PORTFOLIO HOLDER DECISION NOTICE

TOPIC – TRAFFIC REGULATION ORDER – COLEBROOK STREET, WINCHESTER

Title:
**PROPOSED RESTRICTIONS
COLEBROOK STREET
WINCHESTER**

Scale: NTS	Date: 24/05/2016
Drawn: NVC	Checked:
DRG. No. 810402/340/001	Status:

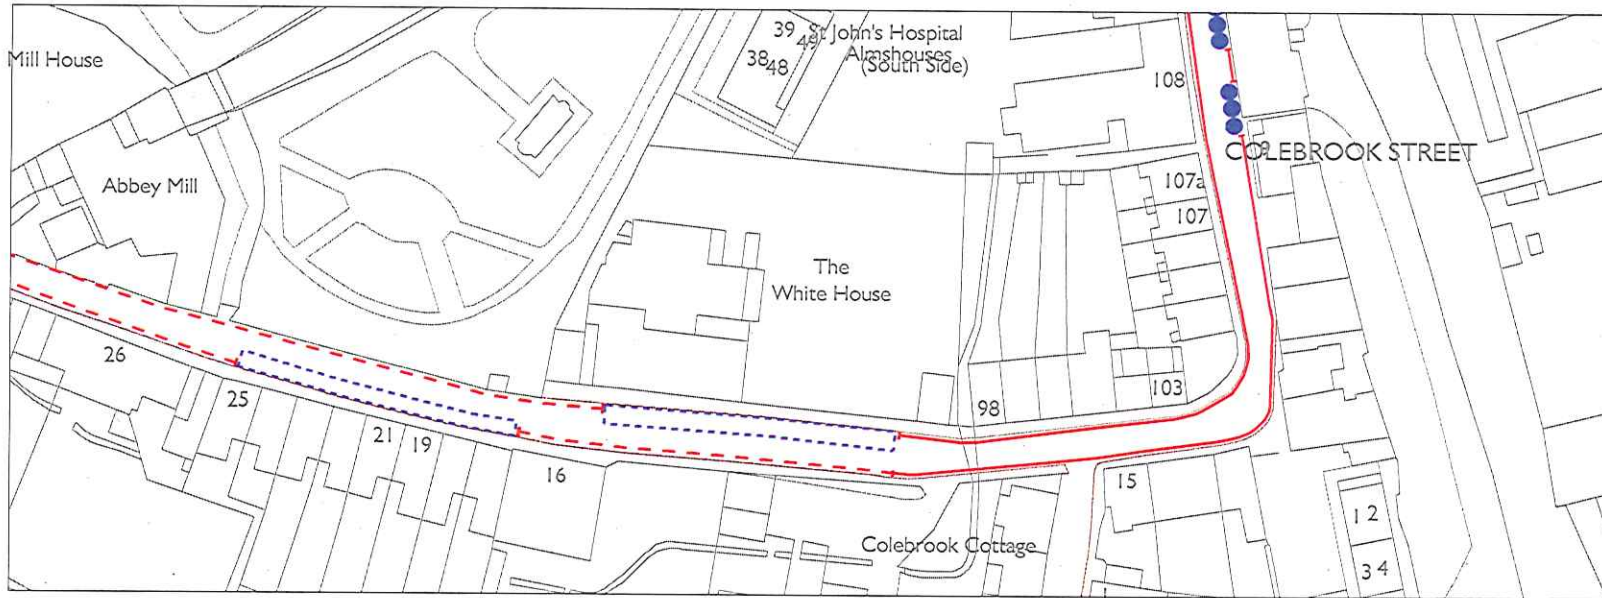
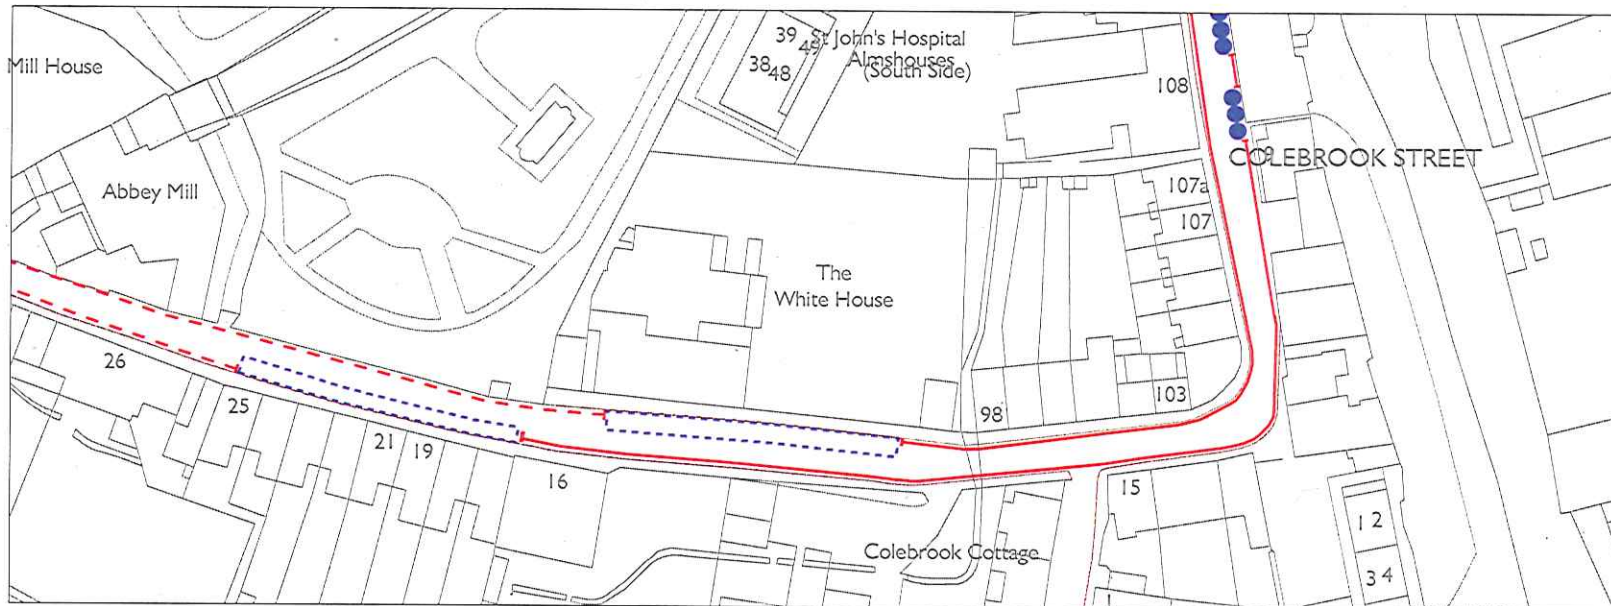
As residents of Colebrook Street we are writing in response to the proposal to implement double yellow lines at the West end of this street.

We feel that the council should now try to alleviate our parking problems rather than just paint double yellow lines, which will aggravate our situation further.

One suggestion we would make is that the left hand pavement from The White House to the corner be removed – it stops at The White House anyway and there is a pavement on the other side continuing the full length of the street so pedestrian safety would not be compromised. People rarely walk on this side of the street unless accessing parked cars. This would create space for double sided parking without obstruction of either road or pavement.

We also think it would be possible to extend the parking bays on the South side of the street by at least one car space – every little helps!

I have received your letter regarding the waiting restrictions in Colebrook Street. I have some major concerns on this, although I agree that something must be done.

I understand the pavement parking is inconvenient but to take additional parking away and again to replace it with absolutely nothing is ludicrous. Please would you let me know what you are going to do to provide alternative parking for residents? I have sat in traffic for over two hours on a Sunday trying to park in an S bay. You are simply making the problem worse. There are so many options open to you but it seems no consideration has been given to any of them.

We wholeheartedly support this proposal as the number of motorists who park ON the pavement, therefore straddling the single yellow line which is currently there, is a constant worry.

We have witnessed back-logs, particularly on weekends, when there isn't space for traffic to pass each other as the road has become too narrow. Not only is it too narrow for cars it is too narrow for the Emergency Services' vehicles to get through the remaining space.

We write in support of the proposal to restrict parking on the south side of Colebrook Street by painting double yellow lines for the following reasons of safety.

We would write in support of the proposal to extend the no waiting at any time provisions in the above street.

A major concern is the restriction of the road width as our own and other vehicles have been damaged by passing cars, vans and lorries. Also, we understand that a minimum of 2.1m is required for emergency vehicle access. With cars parked on both sides of the road this distance is not always achievable.

I am wiring to voice my objections to the changes see my bullet points below.

b) remove the pavement on the the north side of the road by The White House increase the depth of the parking bays so cars can park vertically rather than horizontally, thus fitting more cars.

Regarding the above proposal, I would be delighted if the Council would proceed with this change.

As a person with limited mobility the footpath here is not easy due to the uneven pavement, and cars parked partly on the pavement can make it more difficult still.

- That restrictions be introduced as detailed in the schedule attached (Appendix 2).
- That the Head of Legal and Democratic Services be authorised to make the necessary order.
